SHEET		1		OF		1	
MESA TOPS AT RIDGEGATE		ENTRANCE ROAD ALT A — W/O WALLS					
JOB NO.		15950.12

MESA TOPS AT RIDGEGATE
ENTRANCE ROAD ALT B
WI WALLS

PRELIMINARY ROAD REDESIGN
ALTERNATIVE 1
MESA TOPS – CABELA DRIVE
1595018
10/28/2024
SHEET 1 OF 2

CABELA DRIVE	PLAN & PROFILE
--------------	----------------

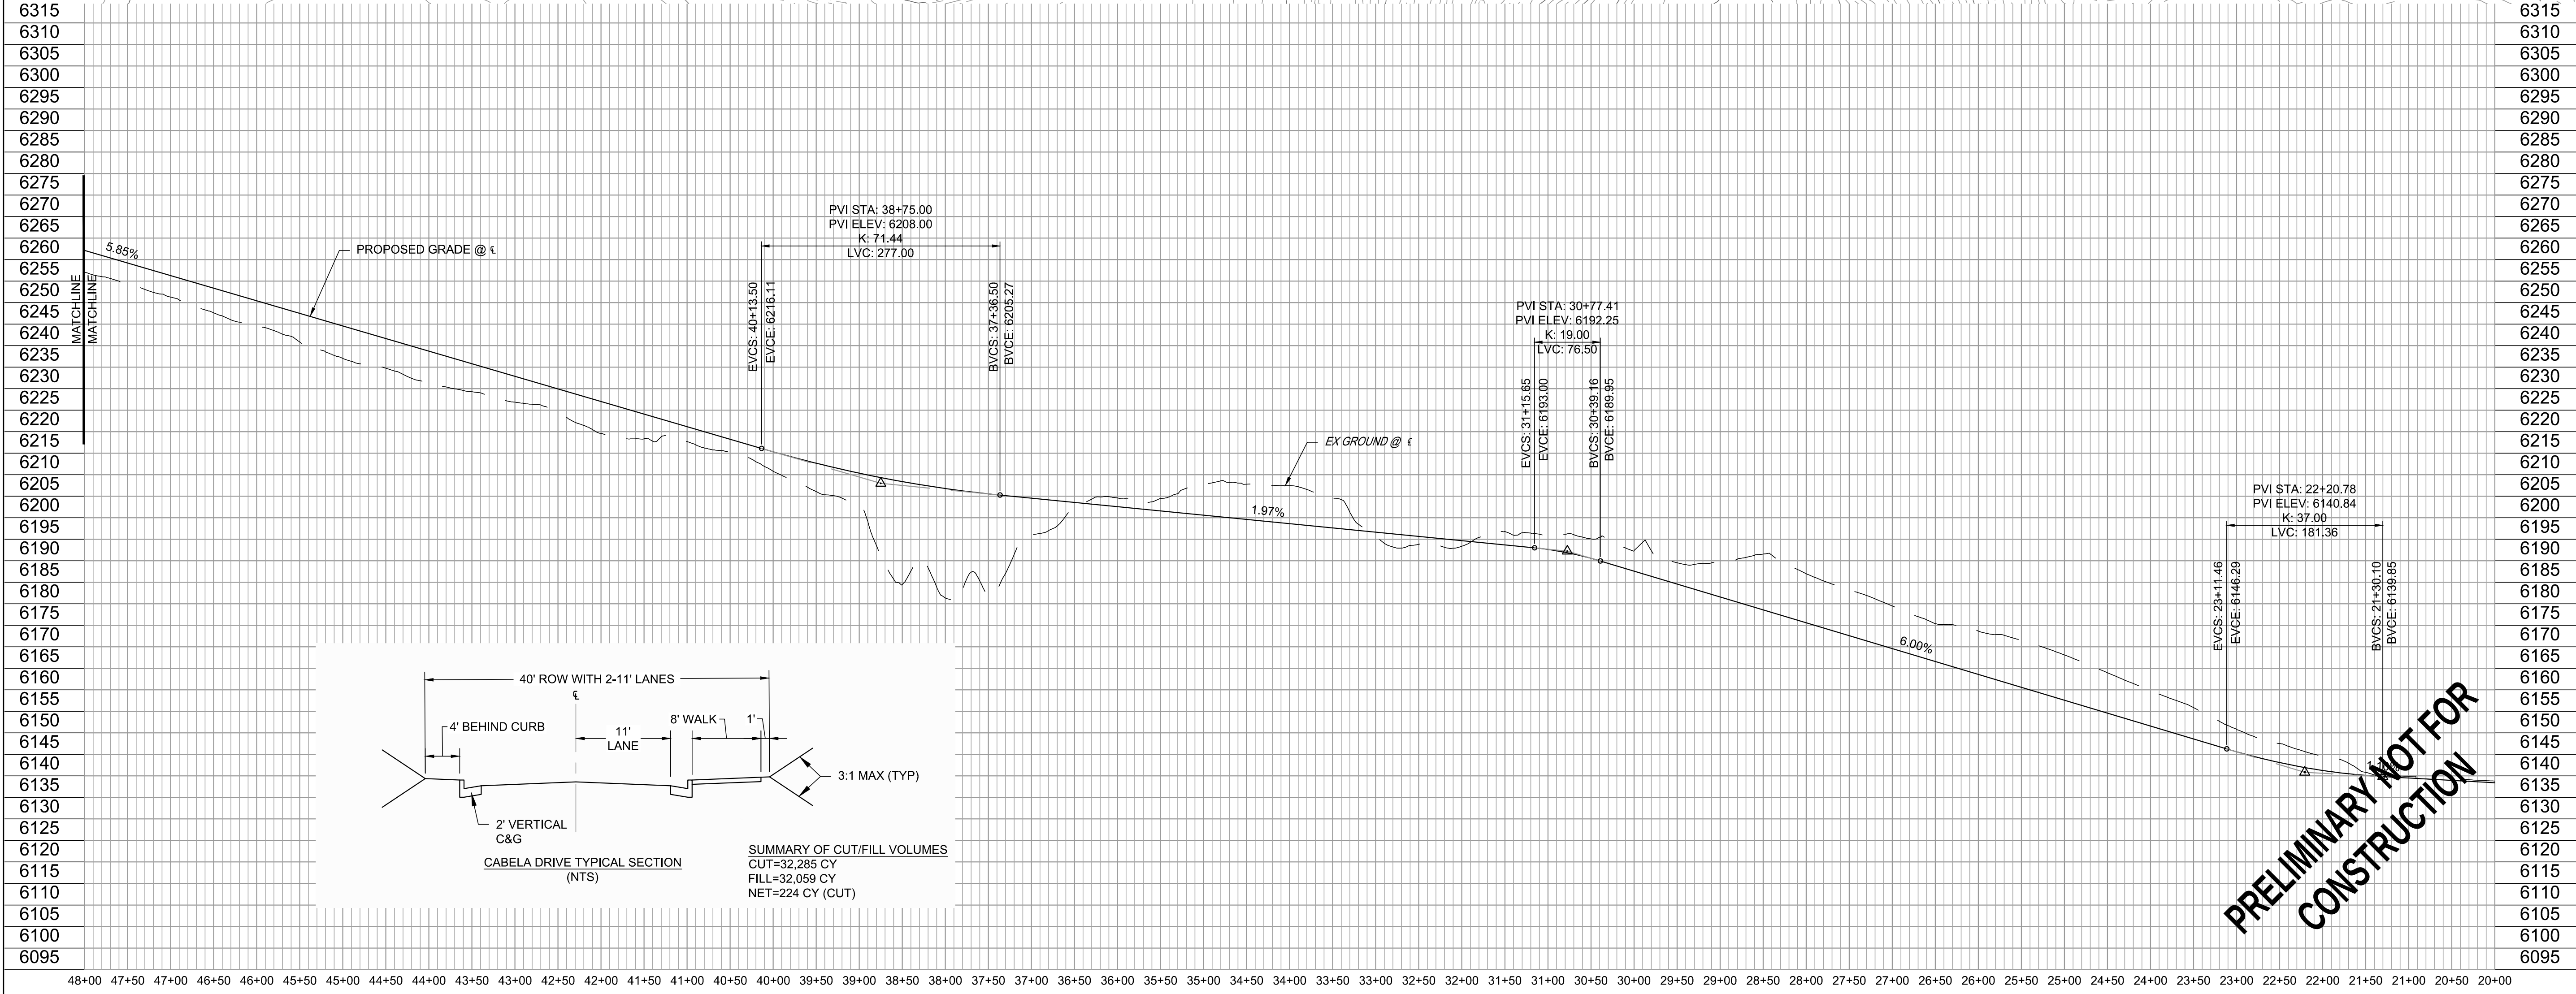
Option not selected -

- Original alignment prepared for the City 8 years ago. The general alignment was used; however, current collector road criteria was applied for both horizontal and vertical curves.

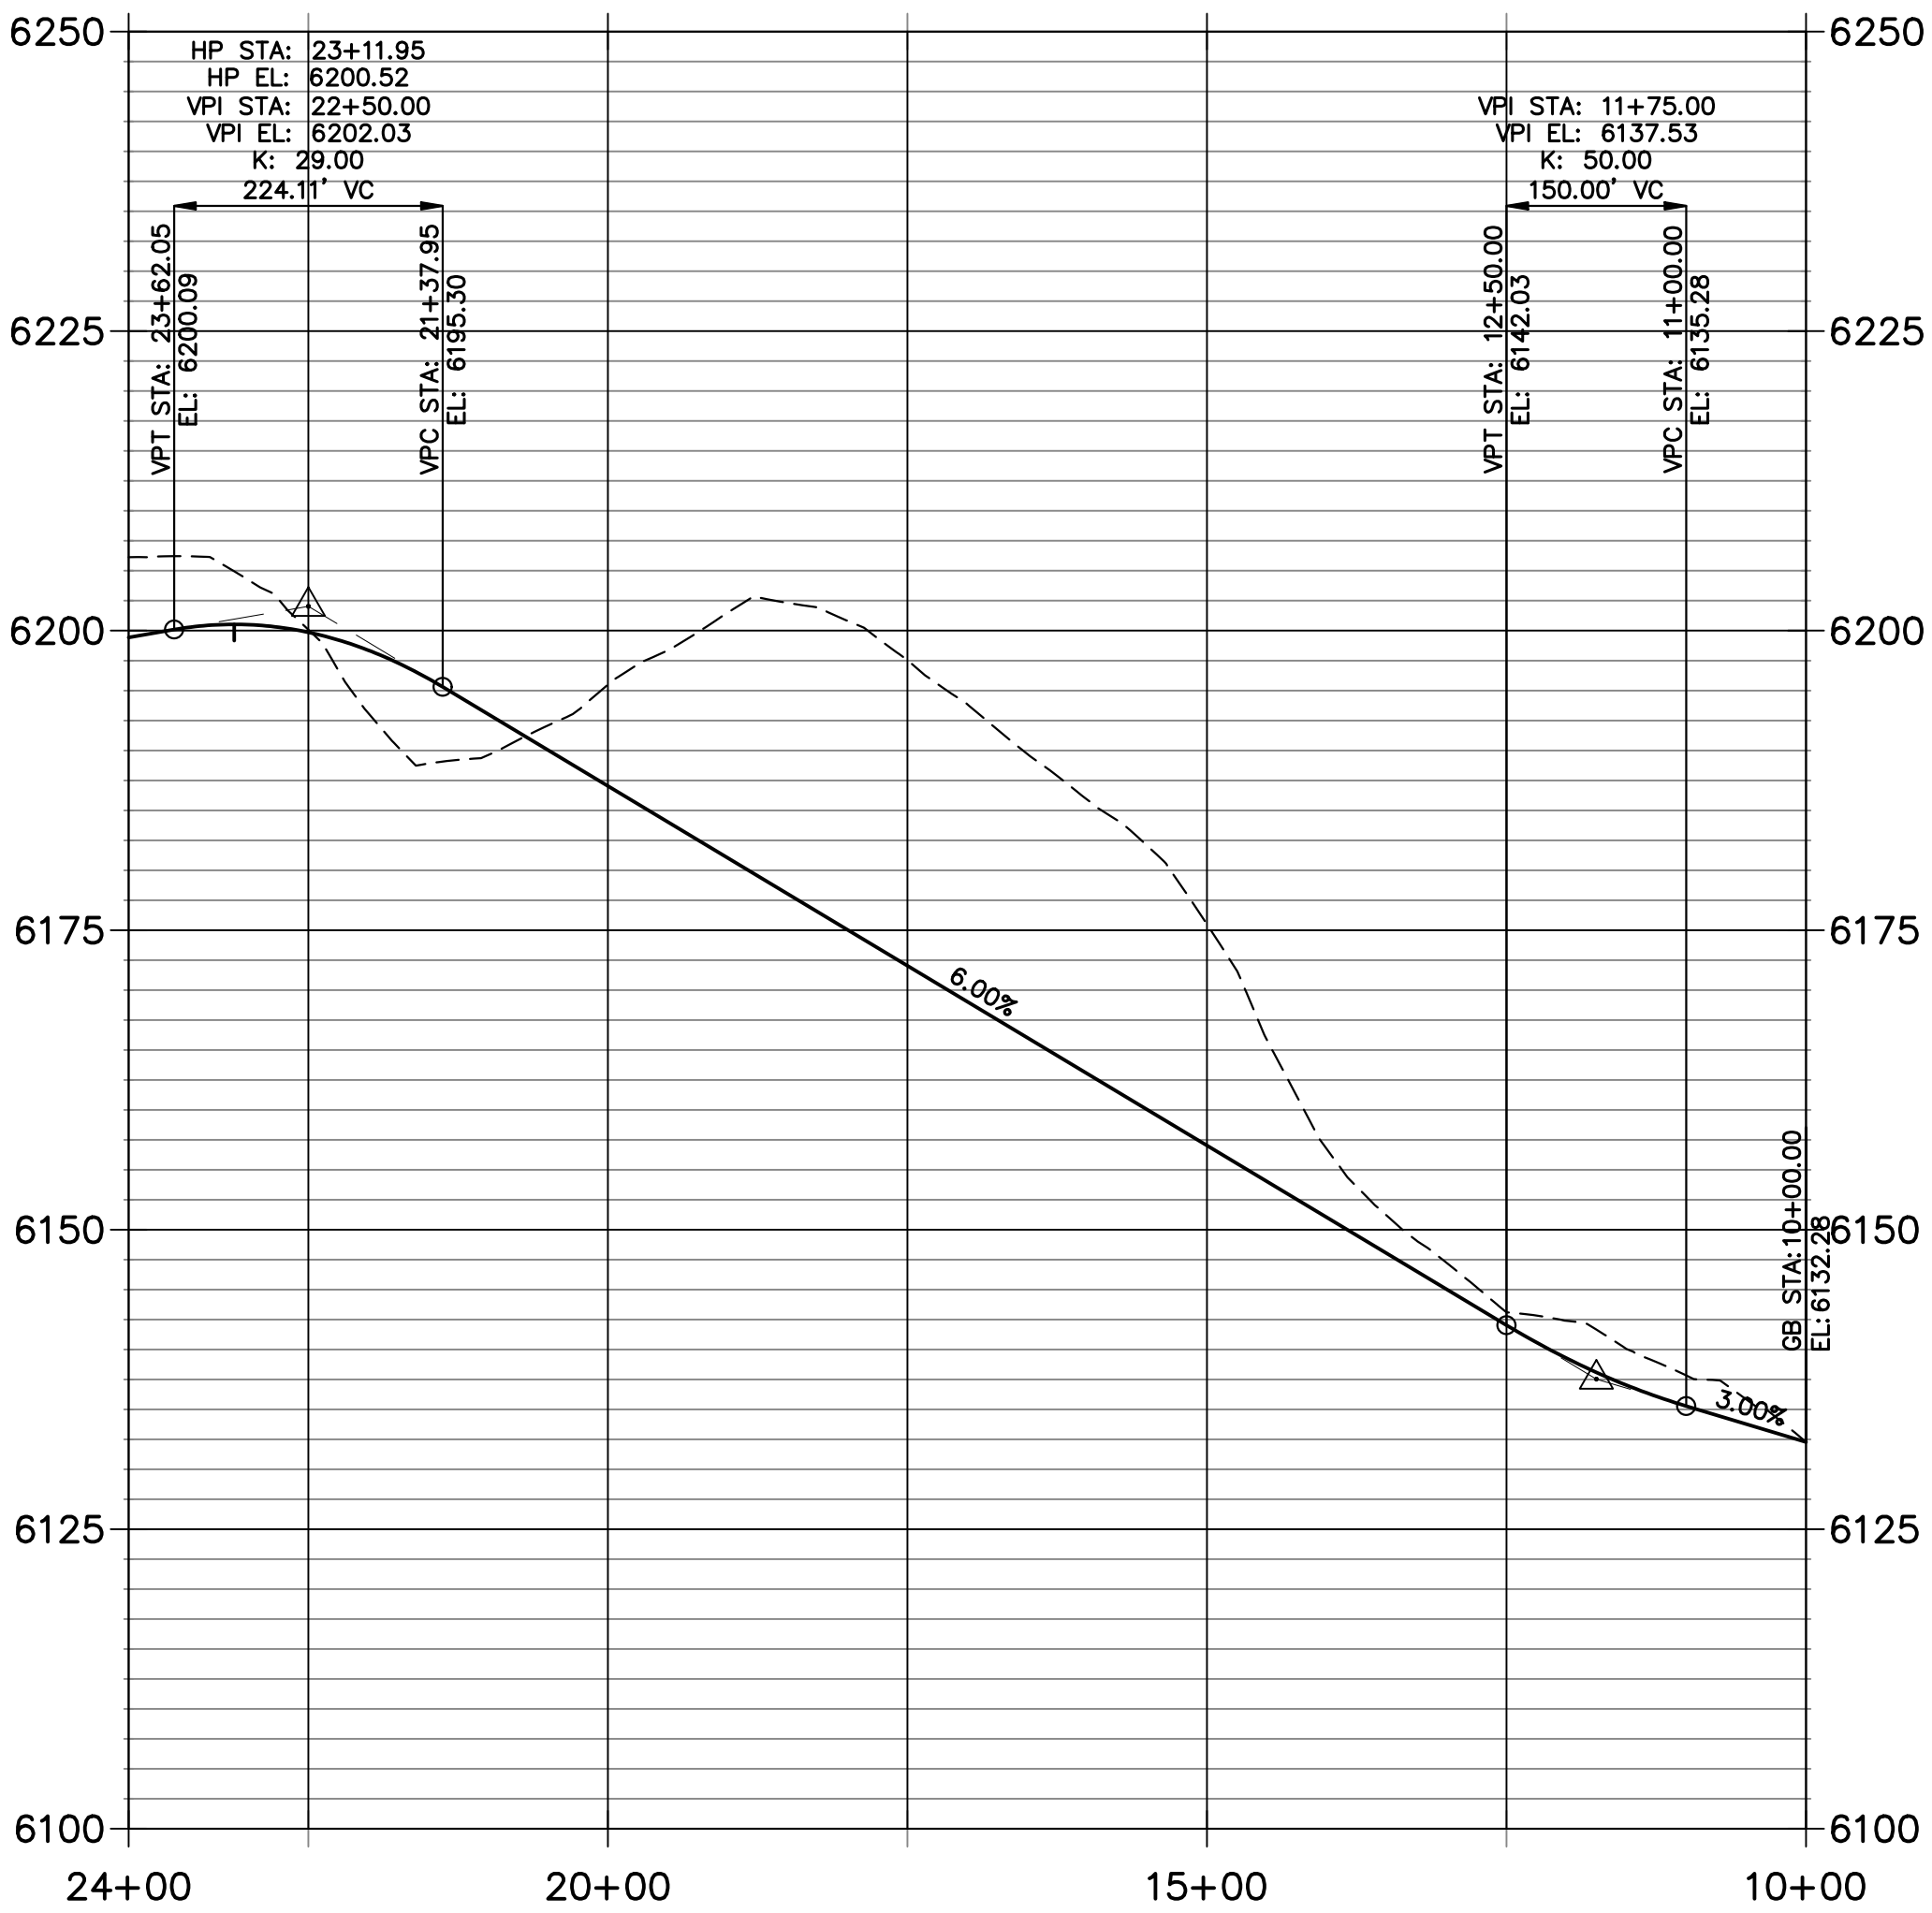
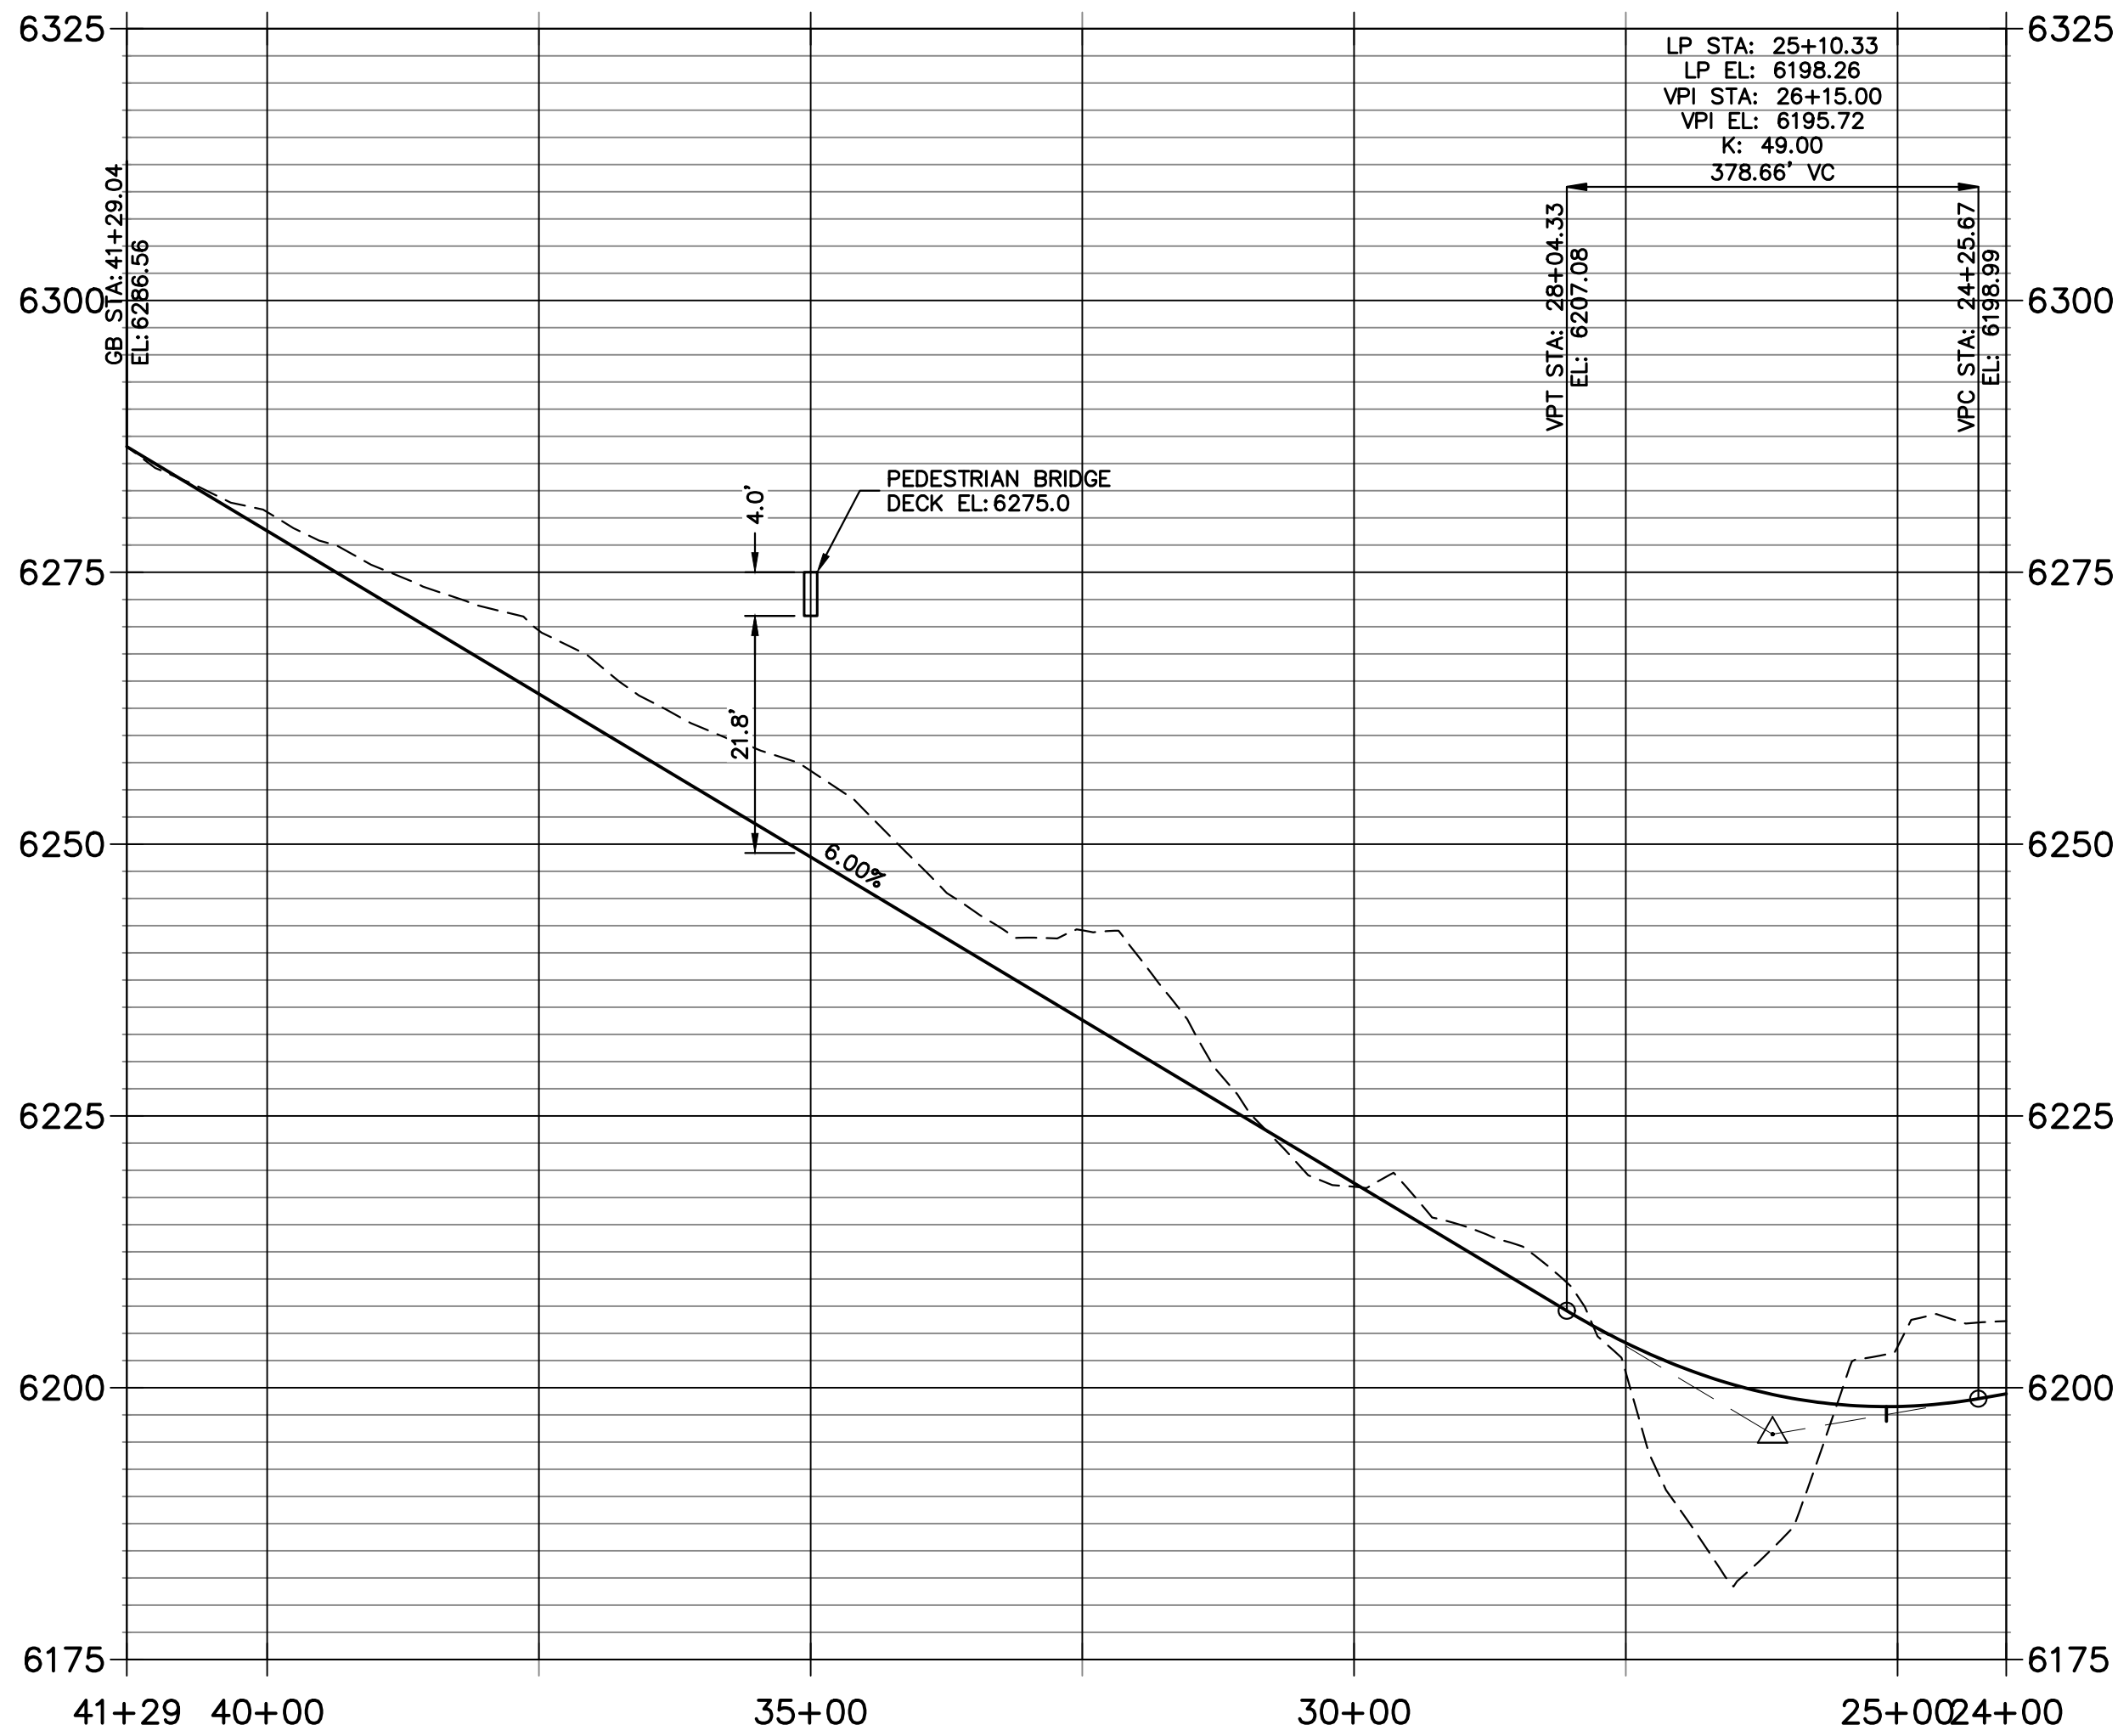
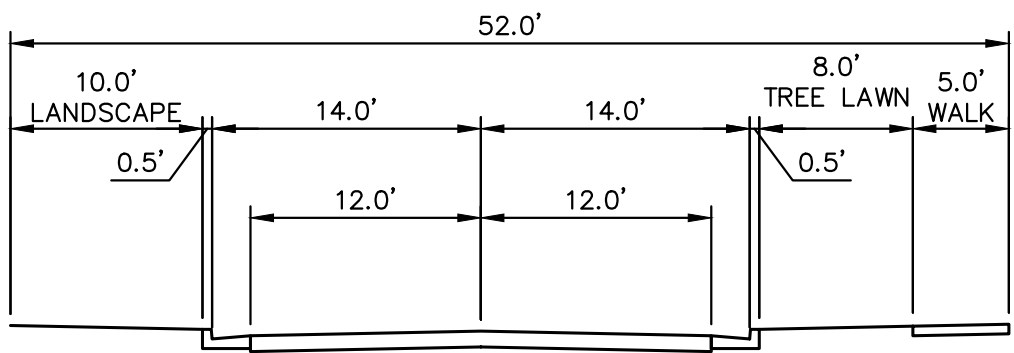
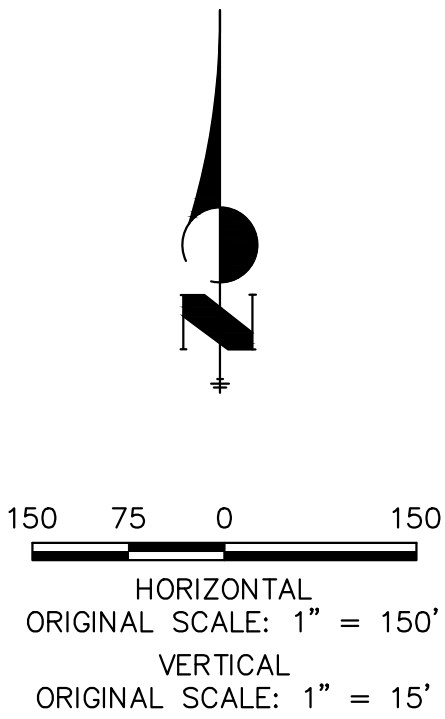
Option not selected -

- Grading extents too intrusive with no retaining walls.
